## Kirkton, Fraserburgh

# Masterplan Update

May 2016

Figure 1: Updated Masterplan

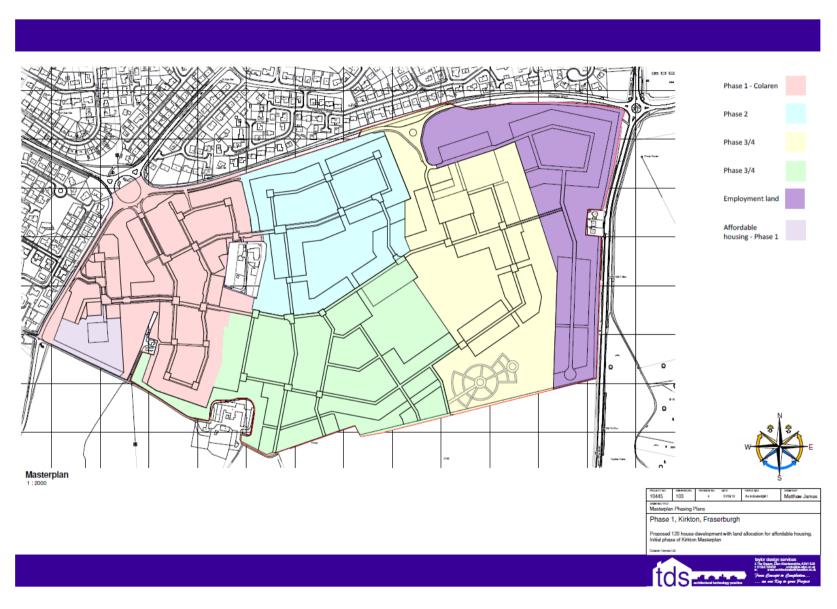
- 2.1 Paragraph 6.12 of the approved masterplan states that the first phase of the development will provide 30% affordable housing. Aberdeenshire Council have advised that the requirement is for 25% affordable housing within the first phase. As a result of the change from 30% to 25% affordable housing, the updated masterplan shows that the first phase will provide land for 37 affordable units to be delivered by Aberdeenshire Council.
- 2.2 The developer is required to provide 3 acres of serviced land to Aberdeenshire Council to provide the affordable housing as part of the first phase. Figure 18 and Figure 19 of the approved masterplan identify the south-east corner of phase one for the affordable housing. The updated masterplan in Figure 1 of this report shows that the first phase provides affordable housing in the south-west corner of the site.

- 2.3 Paragraph 6.63 to 6.71 of the approved masterplan contain the open space strategy. The updated masterplan in Figure 1 of this report shows that the first phase contains a large central park. This area will be accessible for all residents and will create an attractive vista when entering the development. The updated masterplan also contains open space in the future phases that is far more functional and usable.

- 2.4 Paragraph 6.6 of the approved masterplan envisages that 40% of the site will be retained as open space. The updated masterplan in Figure 1 of this report contains 35% of the total site area in the first phase as open space. The shortfall in open space will be made up in future phases of the masterplan which includes potential playing fields and a cemetery.

- 2.5 Paragraph 6.67 of the approved masterplan states that the first phase will contain allotments should there be demand for such a facility. The updated masterplan in Figure 1 of this report shows that the allotments will be provided in a future phase of the development if required.
